Access Compliance Report

Public Rights-of-Way

(Curb Ramps)

Intersection ID: 7770	Main Street: E_ARROWHEAD_DR	Cross Street: N_TRYON_ST	Location: NE
ADA ID: 12F629AC2F76	Ramp Type: Perp	Initial Pass/Fail: Fail	Overall Compliance: No
		Severity Score: 10

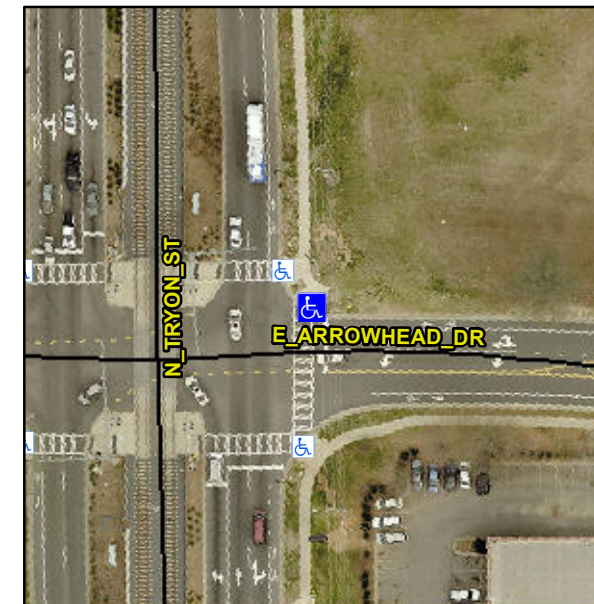
R304.5.1

Compliance	Description	Data	Compliance	Description	Data
N/A	Ramp Length (in)	96.0	Yes	Ramp Slope (%)	5.7
No	Ramp Width (in)	47.0	Yes	Ramp XSlope (%)	2.8
N/A	Flare Type LT	N/A	N/A	Flare Type RT	N/A
N/A	Flare Slope LT (%)	N/A	N/A	Flare Slope RT (%)	N/A
N/A	Flare Traversable LT?	N/A	N/A	Flare Traversable RT?	N/A
N/A	Landing Length (in)	N/A	N/A	DWS Provided?	N/A
N/A	Landing Width (in)	N/A	N/A	DWS Contrast?	N/A
N/A	Landing Slope (%)	N/A	N/A	DWS Length (in)	N/A
N/A	Landing X Slope (%)	N/A	N/A	DWS Full Width?	N/A
N/A	Landing Curb? (Y/N)	N/A	N/A	DWS Offset (in)	N/A
N/A	Shared Landing?	N/A			
N/A	Gutter Ponding?	N/A	N/A	Gutter Slope (%)	N/A
N/A	Gutter Lip Ht (in)	N/A	N/A	Gutter X Slope (%)	N/A
N/A	Painted X Walk1?	Yes	N/A	Painted X Walk2?	N/A
	X Walk 1 Direction	To S		X Walk 2 Direction	N/A
N/A	X Walk 1 Width (in)	107.0	N/A	X Walk 2 Width (in)	N/A
	X Walk 1 Slope (%)	0.4		X Walk 2 Slope (%)	N/A
	X Walk 1 X Slope (%)	4.0		X Walk 2 X Slope (%)	N/A

Remove & Replace Entire Ramp.
